BEFORE THE PUBLIC UTILITY COMMISSION

LC 73

PORTLAND GENERAL ELECTRIC
COMPANY,

2019 Integrated Resource Plan.

FIGURE 7-13: Cost versus variability for the preferred portfolio

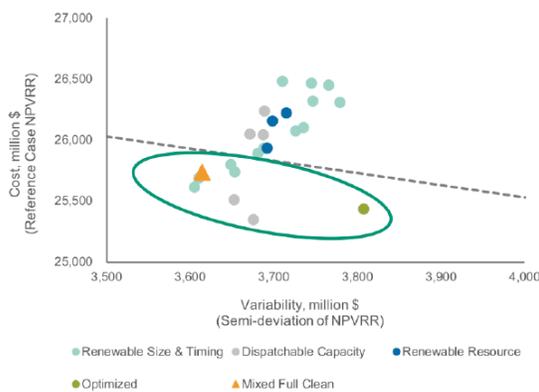
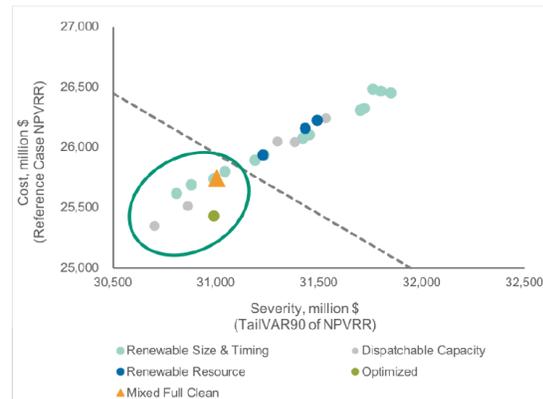
This approach to constructing a new preferred portfolio based on “reasonable actions” from other well performing portfolios is somewhat puzzling, and may present another blunt instrument in portfolio selection. Staff finds this approach particularly curious given that the Mixed Clean Full is outperformed by others in terms of cost and risk, as shown by PGE’s graphics:²⁰

PGE should provide an analysis comparing its preferred portfolio to other top-performing portfolios for cost and risk, and explain why the Company believes it has chosen a portfolio with the best balance of cost and risk, as required by the IRP guidelines.

Recommendation 4: As PGE adjusts its IRP analysis in accordance with Staff's comments, including the removal on non-traditional screens, PGE should provide additional information:

- Provide a quantitative comparison of its preferred portfolio to other well-performing portfolios in terms of NPVRR cost and risk.
- Explain why the Company believes its preferred portfolio has the best balance of cost and risk for customers.

PGE's Intergenerational Analysis²²

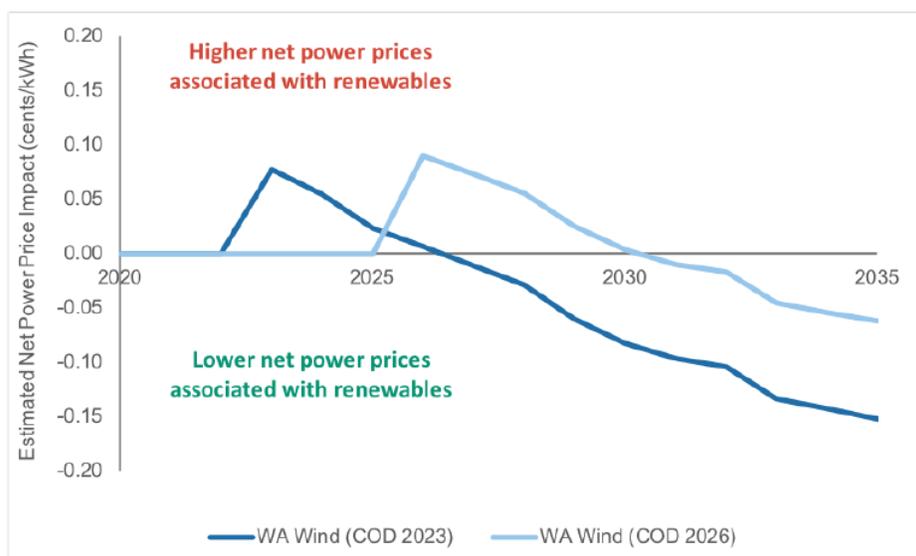
To place additional context on the analysis of a 2026 wind addition, PGE's Appendix G Load Resource Balance indicates that PGE may have an energy deficit by 2025.²³ Staff will conduct additional analysis to consider how the 0.01 cent difference in customer rates compares to the risk of an energy need in 2025, given other assumptions about load growth, voluntary programs, and new Qualifying Facility (QF) contracts that are discussed elsewhere in Staff opening comments.

Many factors could change the effect that a new resource will have on rates, including resource cost and performance, future market conditions, and future customer demand. Staff will continue to assess the inputs and assumptions behind PGE's intergenerational equity analysis. For example, the intergenerational equity analysis may utilize some of the same modeling inputs and assumptions that Staff finds concerning or problematic in the 2019 IRP. Staff hopes PGE will participate in a robust assessment and discussion of the intergenerational equity risks of near-term procurement of renewables.

Customer Type	Reference Case, Forecasted Average Load Growth ⁵¹
Residential	0.1 %
Commercial	0.5%
Industrial	1.9%

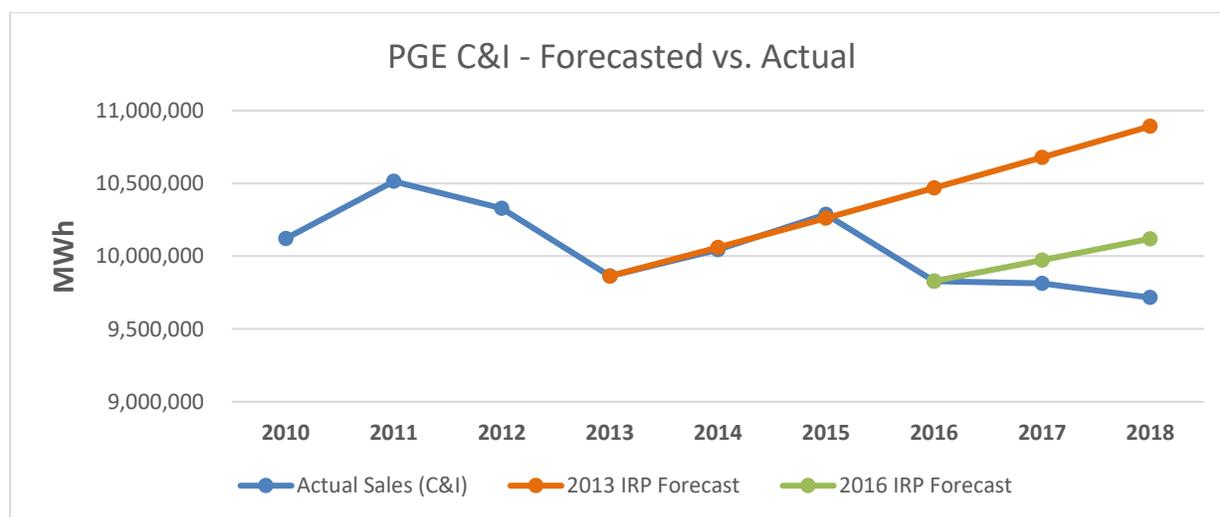
Yet, based on recent trends, Staff is unsure of the accuracy of this IRP’s commercial and industrial load forecasts. Below is a comparison of actual load since 2010 and previous IRP forecasts:⁵²

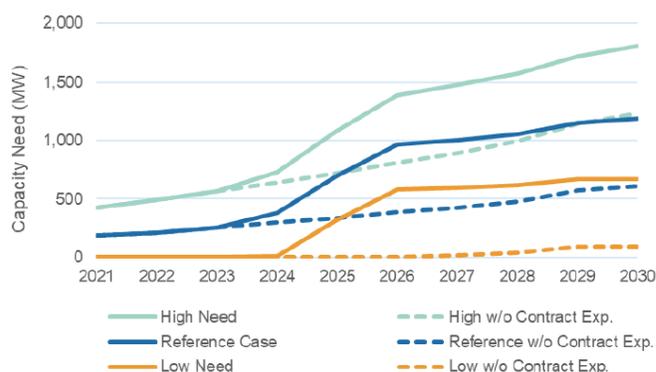
Staff is currently reviewing the forecasted range of capacity needs in the 2019 IRP, which it finds is strikingly broad. Staff is motivated to ensure that the Company gives adequate considerations to capacity adequacy, particularly given the robust discussions in Chapter 3 Futures and Uncertainties and the regional capacity need shown by recent studies evaluated in the Market Capacity Study.⁵⁹

PGE forecasts wide “jaws” of capacity need by 2025, ranging from a low of 0 MW to a high of nearly 1,100 MW of new capacity. The graphic below captures the wide range of possible need.⁶⁰

FIGURE 4-17: Load and existing and contracted generation

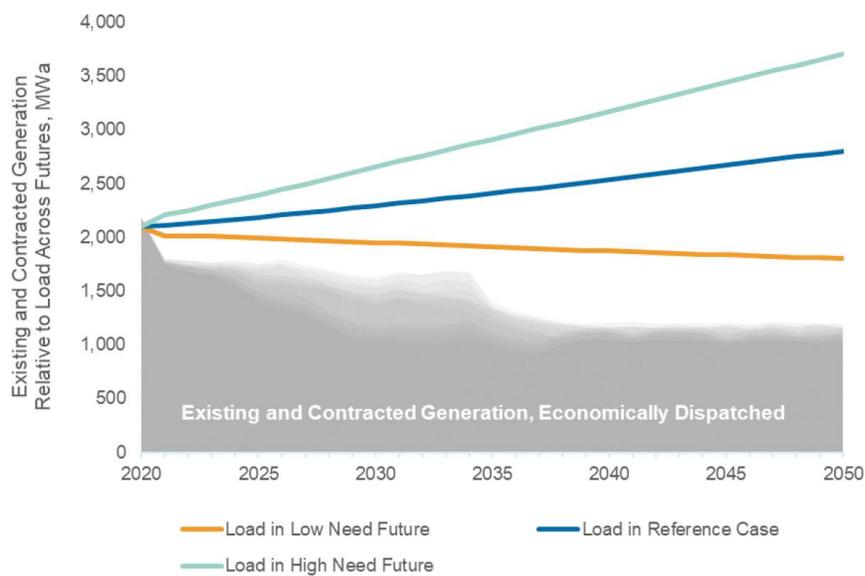
PGE’s new market energy position analysis provides an interesting evolution of the Company’s traditional load-resource balance. Through this analysis, PGE models economic dispatch and compares it to three need futures to demonstrate what it describes as an “energy shortage” (See Figure 4-17).⁶⁶

Yet, when PGE’s resources dispatch economically and market purchases meet the rest of PGE’s load, this is not necessarily an indication that PGE needs to acquire more energy resources. It may simply indicate that market prices are low. PGE’s ‘Market Energy Position’ analysis tells how much energy the company may choose to buy on the market, but in no way should it be used to justify any amount of new resource acquisition.

In a data response to Staff, PGE clarified that its portfolio modeling uses the market energy position to constrain overbuilding of new resources and to calculate GHG emissions, but not to identify when there is a need to add a new resource.⁶⁷ Staff appreciates the Company’s clarification. Staff would have serious concerns with portfolio modeling that bases its energy need on its market price forecast and resulting economic dispatch model.

FIGURE 6-15: Net cost sensitivities for wind

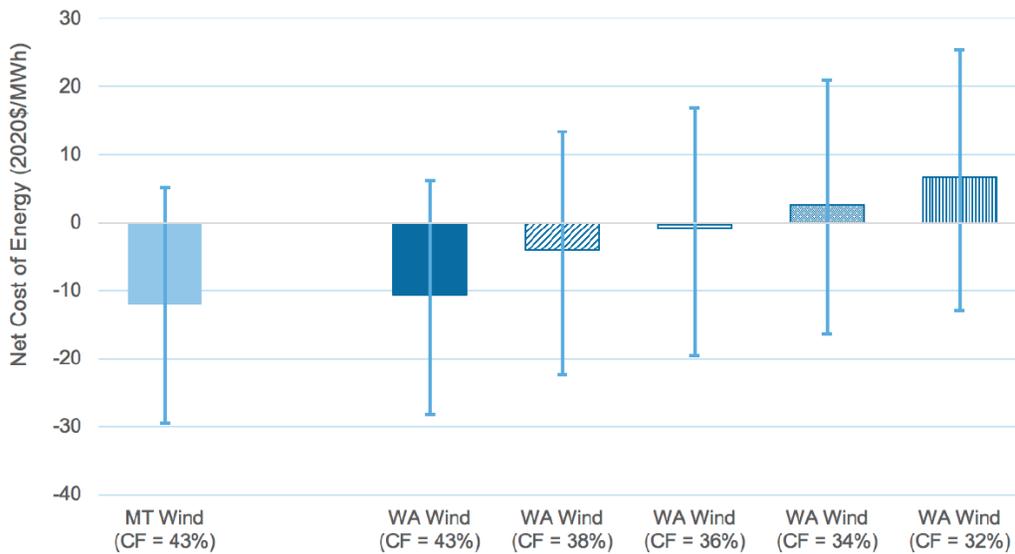
Staff particularly appreciates the sensitivity analysis for wind capacity factors provided in Section 6.5 and Figure 6-15 below.⁸⁹

Staff notes the impact that capacity factor assumptions have on the economic performance of wind resources in PGE’s sensitivity and questions whether the Company’s sensitivity analysis should have been performed on the Mixed Full Clean portfolio to help characterize the risk of acquiring near-term wind assets based primarily on economic performance.

Recommendation 20: Staff requests that PGE provide a sensitivity analysis of the Mixed Full Clean portfolio assuming proportionate changes to the capacity factor of each resource as the assumptions behind the capacity factor sensitivity analysis in Figure 6-15 above.

FIGURE 5-4: Average monthly wind capacity factors by location

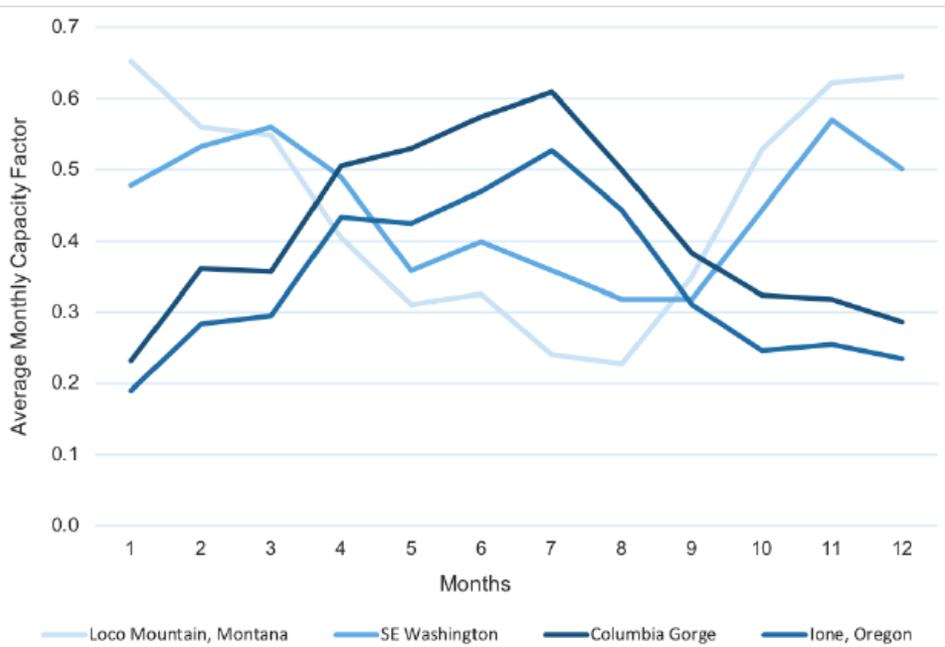
Further, Staff is curious about the relationship between the capacity factor shape of different wind resources modeled in the IRP and PGE’s projected capacity needs. For example, PGE provided a helpful characterization of different wind resources’ capacity factor shapes in Figure 5-4.⁹⁰ Staff notes that the performance of Columbia Gorge and lone, Oregon wind follow the reverse shape to that of Montana and Washington wind.

Given the Action Plan’s lack of specificity regarding resources in the renewable RFP and the future capacity actions, it is particularly interesting to note the relationship between the wind shapes and PGE’s characterization of its capacity need found in figure 4-14.⁹¹
